PSL - PMC

PMC Servo Rev C1

Engineering Change Order History		
ECO number	Date	Originator
1	E010166 to Rev C	RK
2	E010223 to Rev C1	RK
3		
4		
5

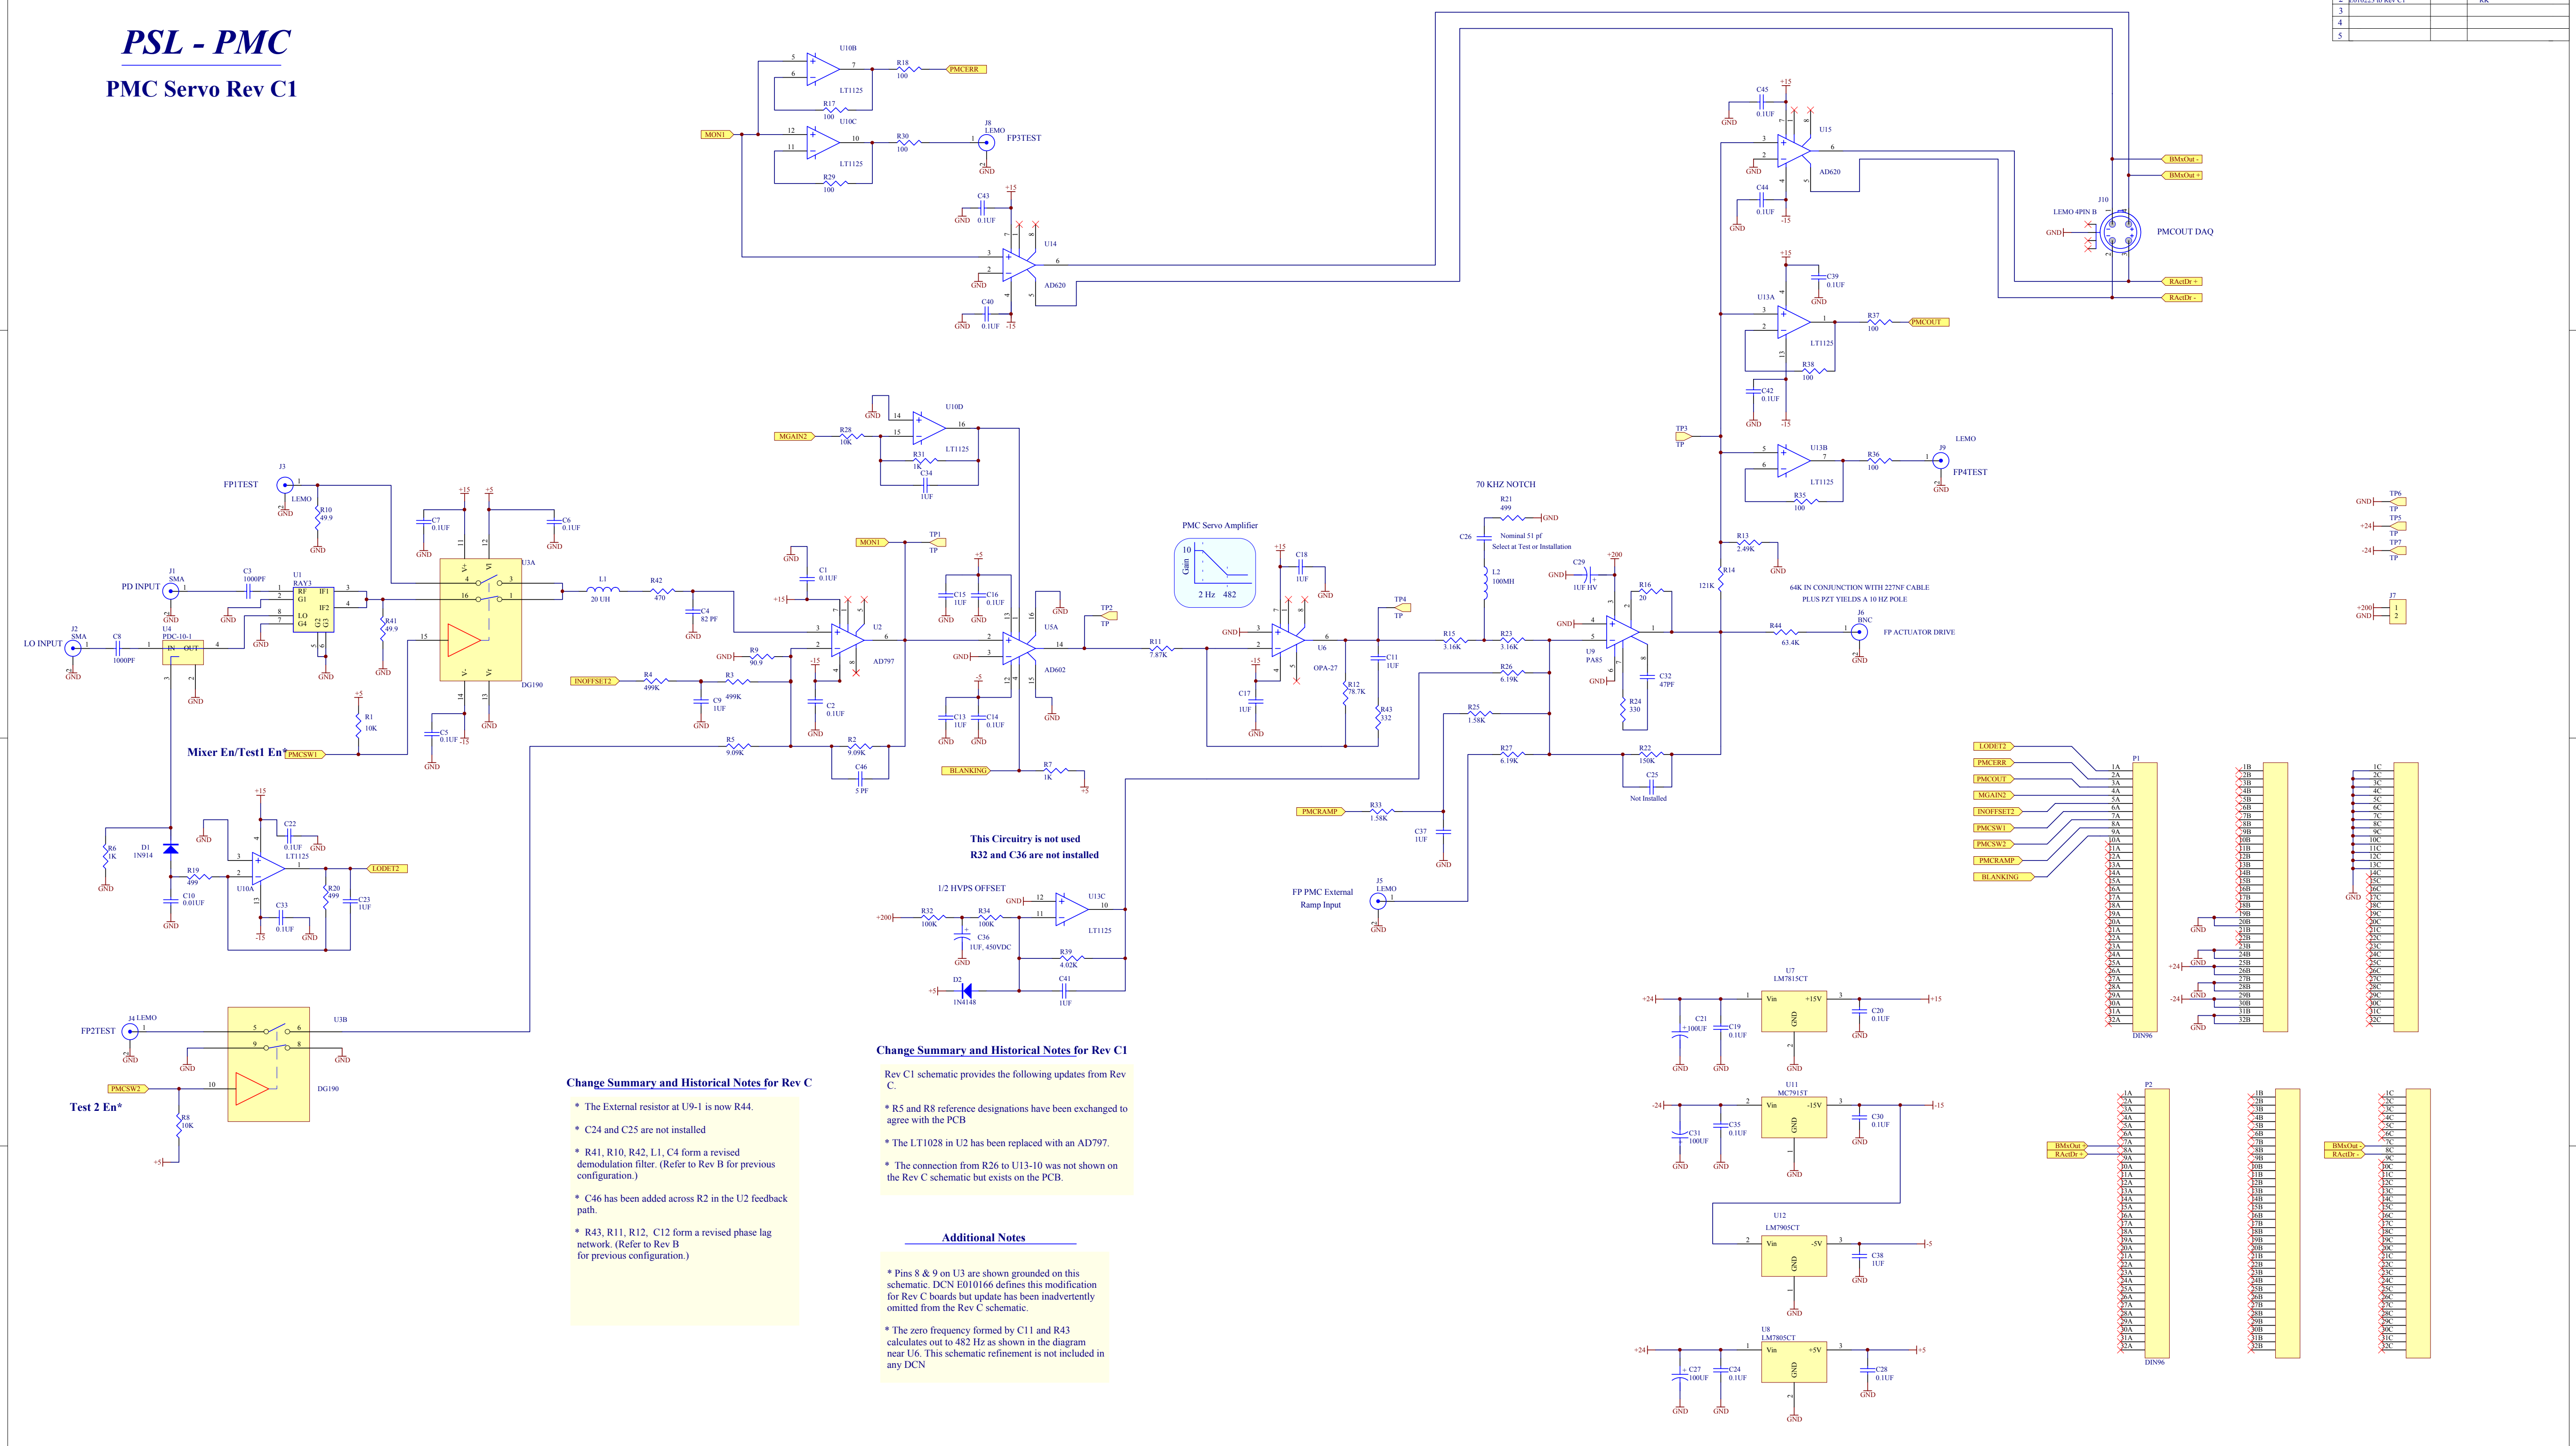
- * The External resistor at U9-1 is now R44.
- * C24 and C25 are not installed
- * R41, R10, R42, L1, C4 form a revised demodulation filter. (Refer to Rev B for previous configuration.)
- * C46 has been added across R2 in the U2 feedback path.
- * R43, R11, R12, C12 form a revised phase lag network. (Refer to Rev B for previous configuration.)

- * R5 and R8 reference designations have been exchanged to agree with the PCB
- * The LT1028 in U2 has been replaced with an AD797.
- * The connection from R26 to U13-10 was not shown on the Rev C schematic but exists on the PCB.

- * Pins 8 & 9 on U3 are shown grounded on this schematic. DCN E010166 defines this modification for Rev C boards but update has been inadvertently omitted from the Rev C schematic.
- * The zero frequency formed by C11 and R43 calculates out to 482 Hz as shown in the diagram near U6. This schematic refinement is not included in any DCN

This Circuitry is not used
R32 and C36 are not installed
